Fern Bay Seaside Village Project Application

Further Response to Submission Report

Date:	7 April, 2010
Partner:	 Paul Douglass

Aspen Group

Martens & Associates Pty Ltd ABN 85 070 240 890		Environment Water Wastewater Geotechnical Civil Management	
Drawn:	SL	SENSITIVITY ANALYSIS BASIN 6	Drawing No:
Approved:	DMM		FIGURE 8
Date:	22.03.10		
Scale:	na		Job No: P0902479

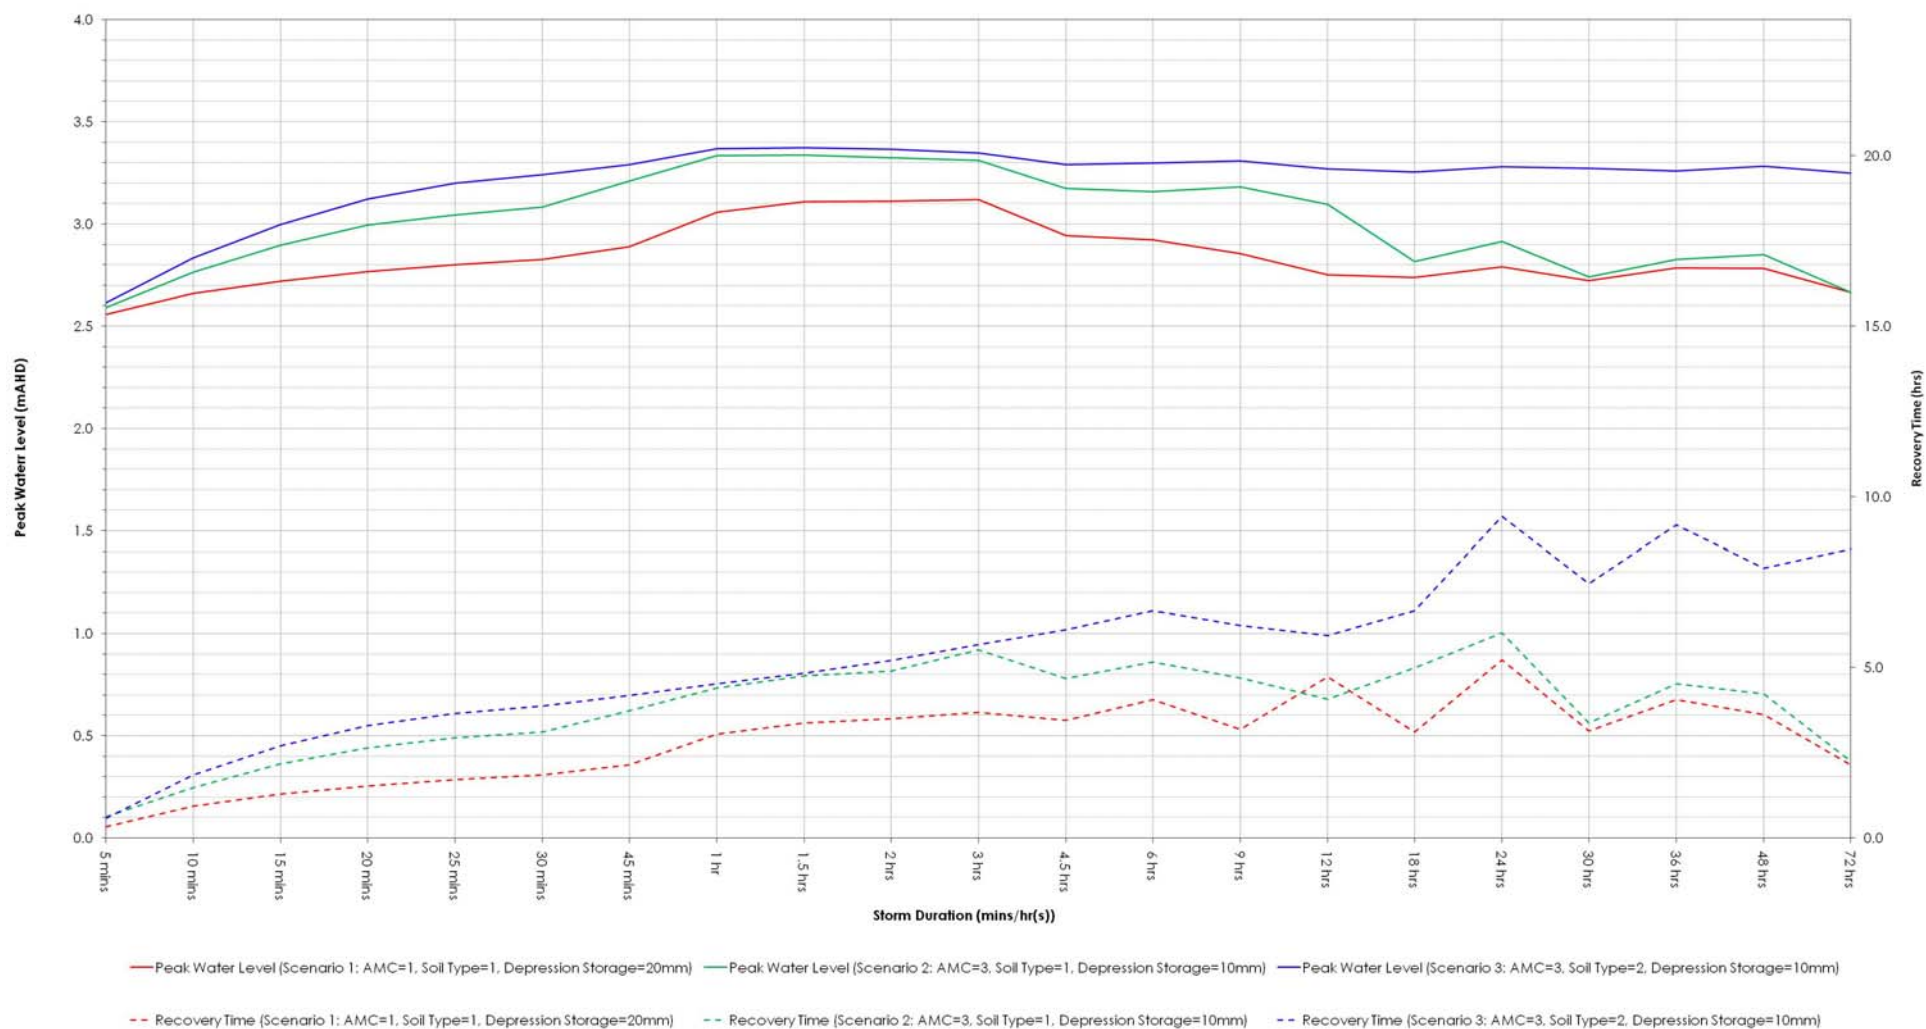
Clarify the likely recovery rate of basin water levels following a 100 year ARI storm event. If basin recovery times are more than a few days, then a sensitivity analysis of the 'embedded storm approach' should be undertaken.

Results of the peak water level analysis are provided in Figure 3 through to Figure 8 and summarised in Table 9.

Results of the basin recovery time analysis are also provided in Figure 3 through to Figure 8 and summarised in Table 10.
